RHODE ISLAND DEPARTMENT OF TRANSPORTATION

RHODE ISLAND CONTRACT NO.2016-CH-055

Pedestrian and Intersection Safety Improvements w/ Albion Beacon - STC

ADDENDUM NO. 1 Prospective bidders and all concerned are hereby notified of the following changes in the Plans, Specifications, Proposal and Distribution of Quantities for this contract. These changes shall be incorporated in the Plans, Specifications, Proposal and Distribution of Quantities, and shall become an integral part of the Contract Documents.

| | | | GENERAL AND LOCATION PLAN NO.20 | |

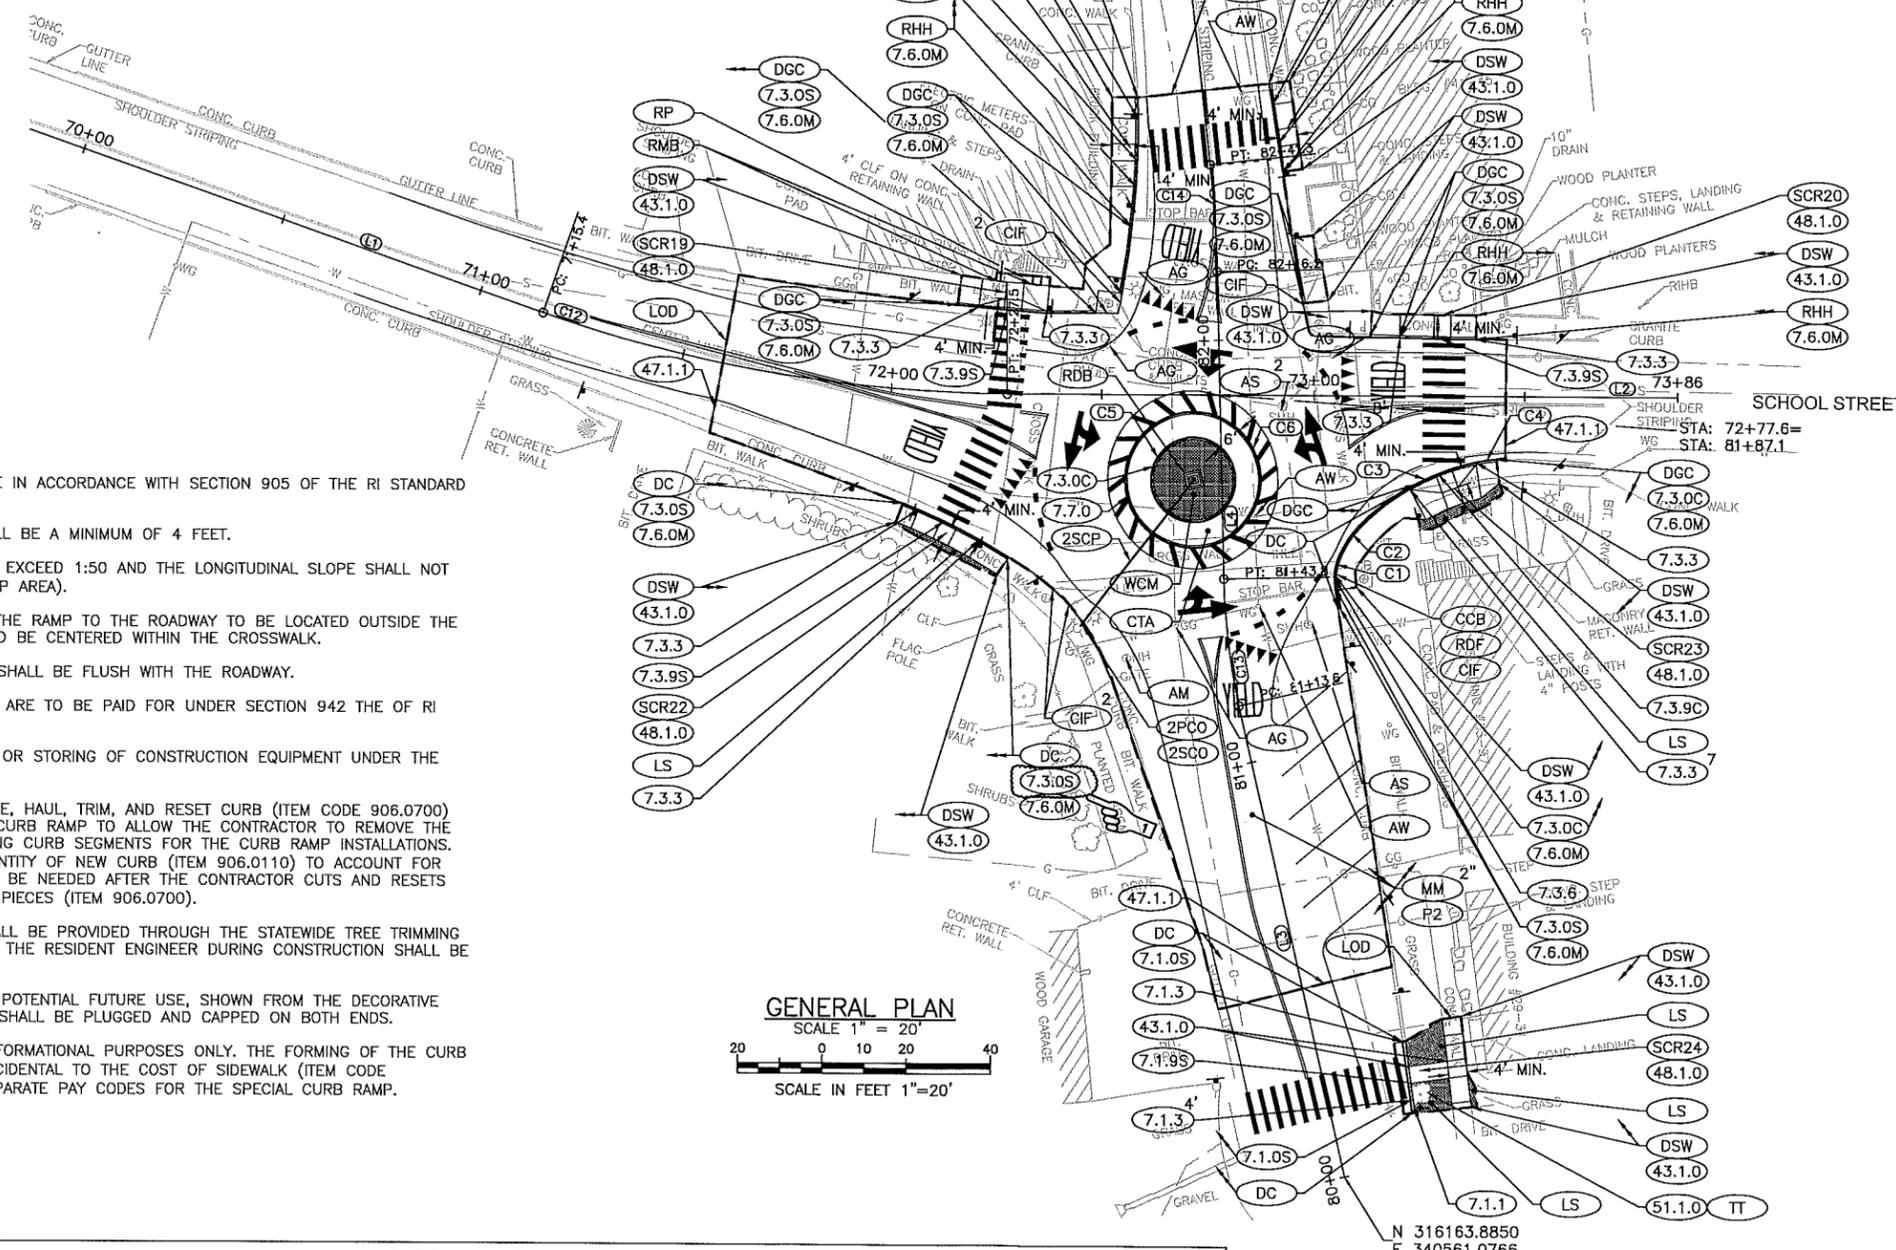
Delete Sheet No. 32 – General and Location Plan No. 20 in its entirety and replace it with Sheet No. 32 – General and Location Plan No. 20 (R-1) attached to this Addendum No. 1. A callout for granite curb at the southwest curb ramp has been added.
